STATE OF NEBRASKA
DEPARTMENT OF ROADS
ADDENDUM NO. 1
AND
ELECTRONIC BIDDING SYSTEM
AMENDMENT NO. 1
PROJECT NO. LCLC-5231(13)
CONTROL NO. 13137
CALL NO. 150
27TH STREET/LEIGHTON VIADUCT, LINCOLN
LETTING DATE: OCTOBER 25, 2012

Sheet 9

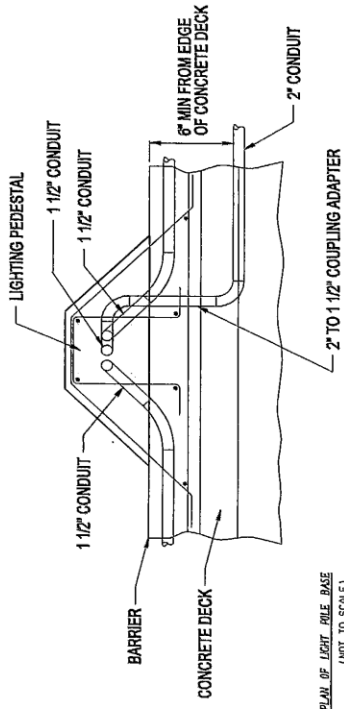
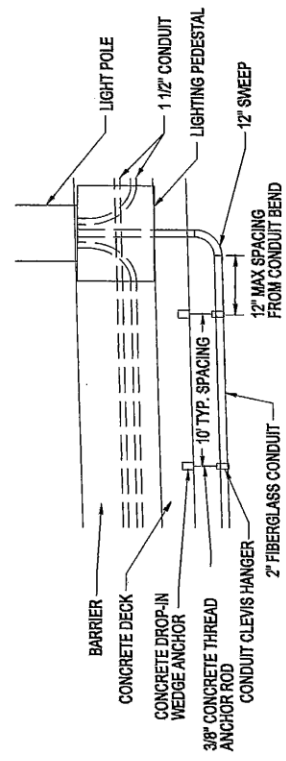
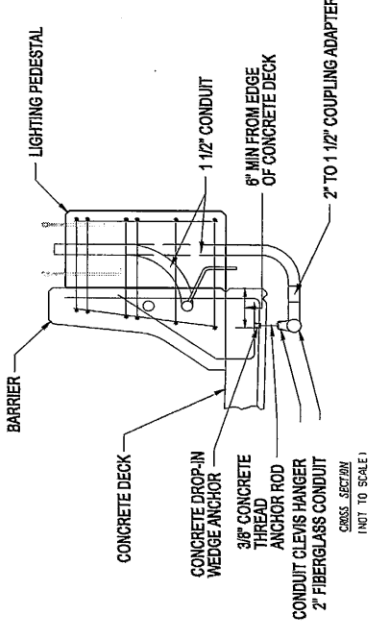
Plan sheet 9 is amended to include the details depicted on the attached sheet.

- 1- CONDUIT ATTACHED TO THE BRIDGE DECK SHALL BE FIBERGLASS CONDUIT WITH EXPANSION FITTINGS AS REQUIRED BY THE MANUFACTURER (SEE BRIDGE PLANS).
- 2- COMMUNICATION AND POWER CABLES REQUIRED FOR THE SENSOR SHALL BE REQUIRED TO BE INSTALLED IN THE CONDUIT WITH THE 2" CONDUIT ON BRIDGE DOWN TO THE CABLES AS SHOWN ON PLANS.
- 3- CONCRETE DROP-IN WEDGE ANCHOR SHALL BE CONSTRUCTED WITH PROPER EMBEDMENT TO HOLD 1000 LB PULL OUT LOAD OR GREATER.
